**PRIVATE PLAN CHANGE 91**  
**HEARING REPORT**  
**80 MCLARIN ROAD, GLENBROOK BEACH**  
**HD PROJECT 2 LIMITED**

**A NOTIFIED PRIVATE PLAN CHANGE TO THE AUCKLAND UNITARY PLAN BY HD PROJECT 2 LIMITED**

**Reporting officer, Katrina David, Planner**

Figure 6: Diagram from Context Analysis

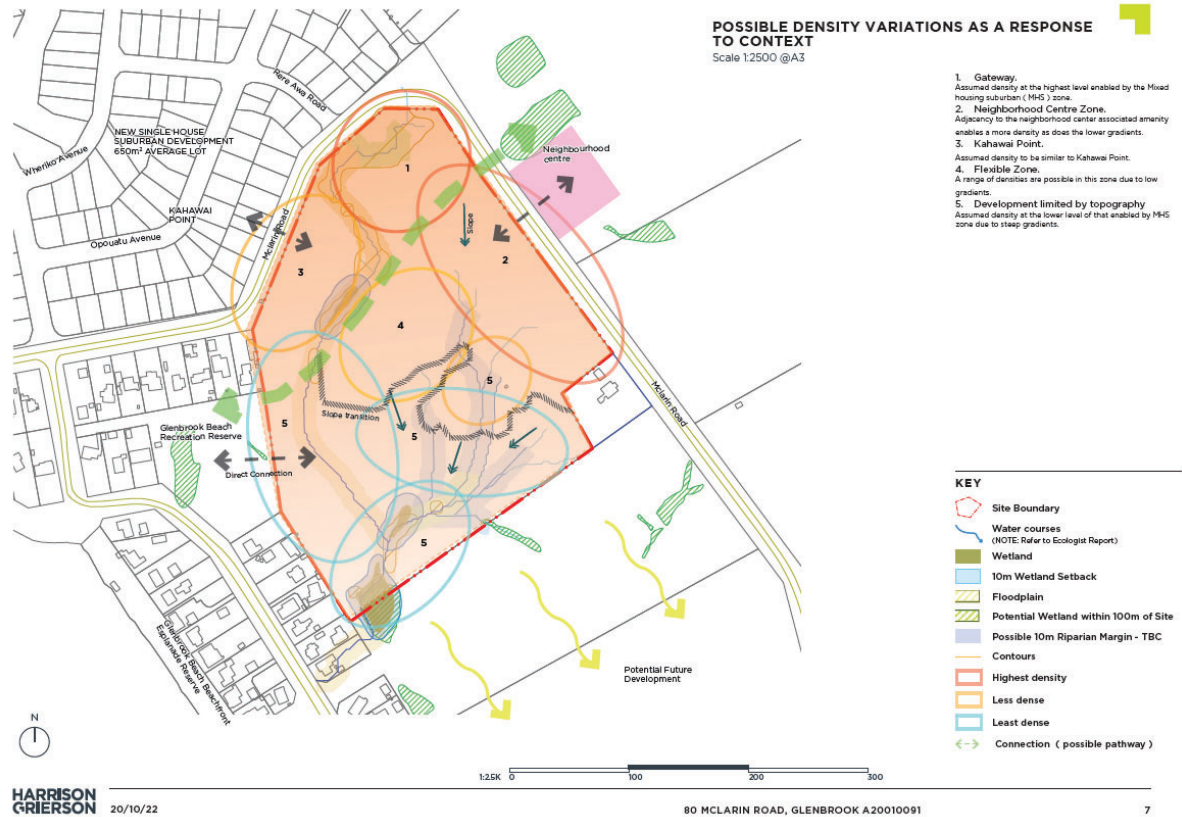
359. The Context Analysis includes several diagrams of the plan change area showing character opportunities and possible density variations in response to context. Notably areas 1 and 2 on the diagram below indicate where the highest level of density enabled by the MHS Zone is expected, whereas the southern half of the site is assumed to have the lower level of density enabled by the MHS Zone due to steeper gradients. See Figure 7 below.

Figure 11: Opportunities and constraints map. Source: Context Analysis RFI response, prepared by Harrison Grierson, dated October 2022

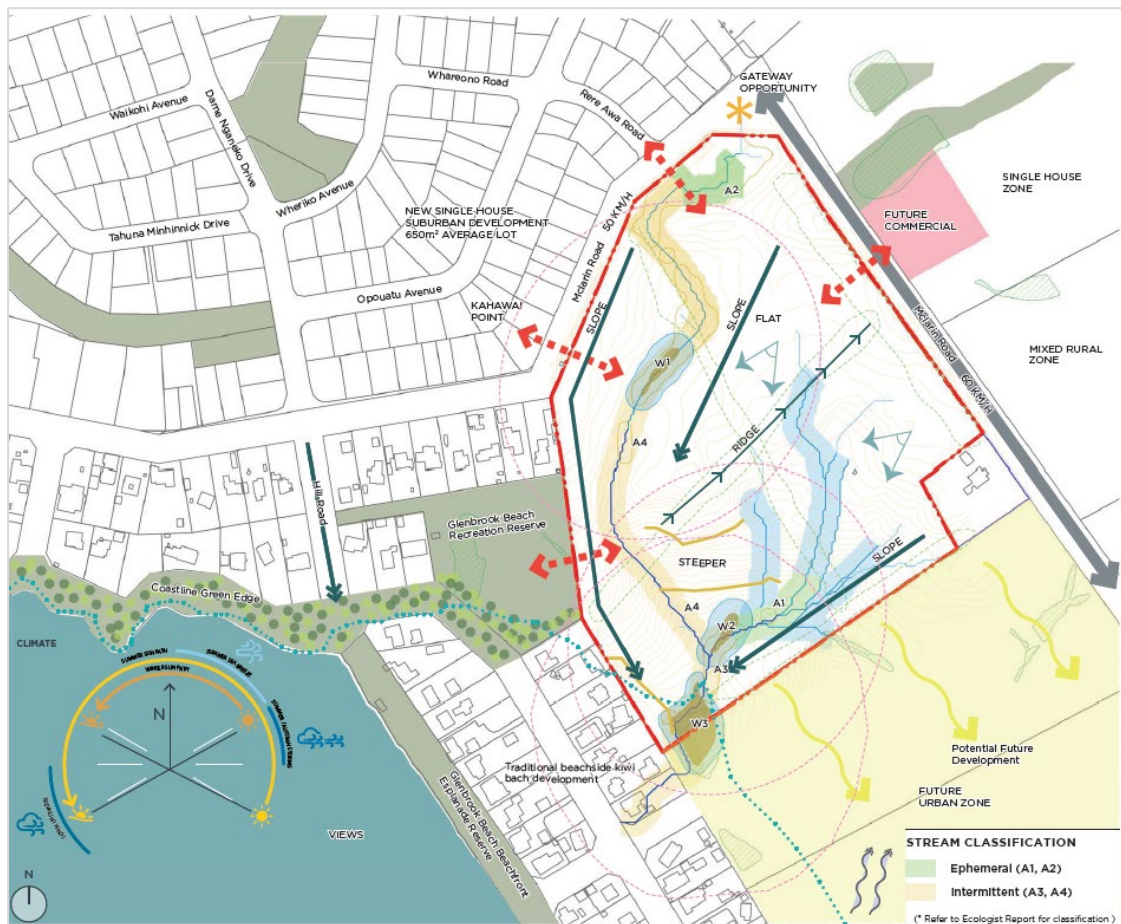
- 4.2 Section 3 includes an opportunities and constraints assessment and a site context, see Figure 11 below. This assessment identifies a number of opportunities. These include greater housing choice, strong sense of place derived from the surrounding context and ecology, extension of the existing urban development area given the proximity to Kahawai Point development, enhancement of neighbourhood connectivity, connections to open spaces and the waterfront, restoration and enhancement of the natural environment, ecological corridors as amenity and character defining elements of place, integration and enhancement of stormwater management, potential for view shafts to natural features including Manukau Harbour and distant Waitakere Ranges, and connections to the proposed Marine Centre via coastal pathways. The key constraints outlined include streams, wetlands and riparian margins on the subject site, topography resulting in possible no build zones, overland flow paths and possible flooding, limited vehicle access due to streams and steep topography, lack of public transport in the area and the possibility that public infrastructure may need to be upgraded.

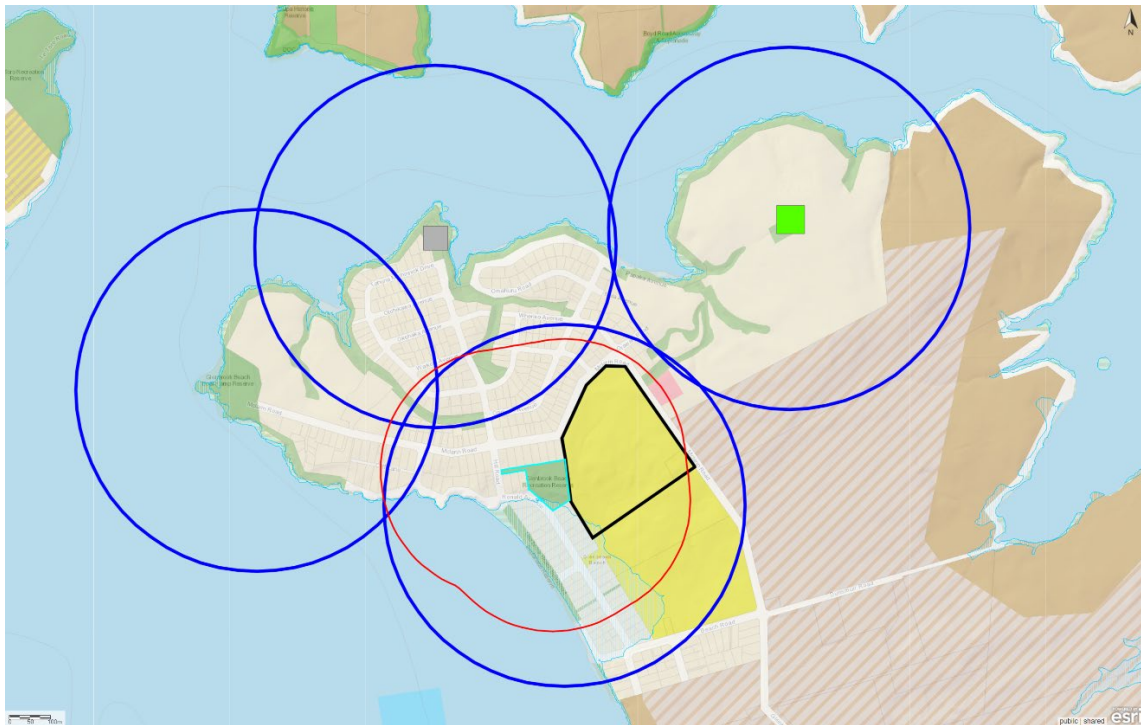
in yellow below in Figure 1) within a 600m walkable catchment area with the exception of a small area in the south-eastern corner. This was based on the expectation that the FUZ area would be zoned Single House Zone. This advice has been confirmed again by the Property Provision Specialist in August 2023.

- 2.7 As Figure 1 confirms both the 600m (SHZ) and 400m (MHS) catchments encompass the whole plan change area and effectively also 140 McLaren Road, no additional open space is therefore required with the plan change and an under provision of public recreational space is avoided. The intended outcomes of the Open Space Provision Policy are met in regard to provision of neighbourhood park. The matter of consideration of appropriate zoning of the plan change area as either SHZ or MHS in regard to neighbourhood park provision is therefore considered resolved from this perspective. It is noted that the final zoning of the plan change area as SHZ or MHS may result in a wider range of the final number of dwellings, which in turn may generate additional open space demands within the plan change area on Glenbrook Beach Recreation Reserve. As the existing reserve currently does not have good public visibility and currently provides limited informal recreation opportunities, an increased population density delivered through the plan change will potentially lead to more utilisation of the reserve and future council investment which is supported.

IXXX.11 Figure 4– Precinct Plan

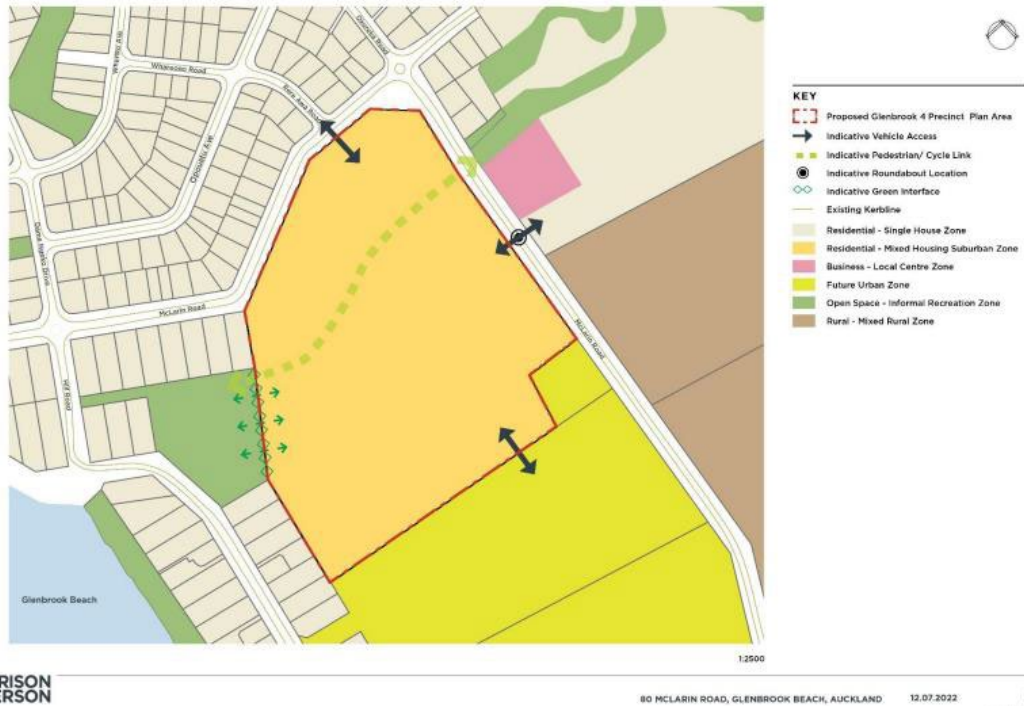
- To implement the indicative connections, pathways, and infrastructure specified in ~~Figure 1~~ of the Glenbrook 4 Precinct Plan (IXXX.11).
  - ~~To XXX~~
1. ~~Development and/ or subdivision shall enable~~ must provide the connections, and pathways, and infrastructure (including the roundabout) to be provided as shown in ~~Figure 1~~ of the Glenbrook 4 Precinct Plan (IXXX.11).
  2. ~~Roads are to be designed in accordance with the road cross sections for this Precinct in Figure 2 of the Glenbrook 4 Precinct Plan.~~
  2. Development and/or subdivision fronting McLarin Road south of the intersection with Okoreka Road and Orawahi Road, must not occur until the roundabout and pedestrian crossing facility shown on the Glenbrook 4 Precinct Plan (IXXX.11) have been provided.
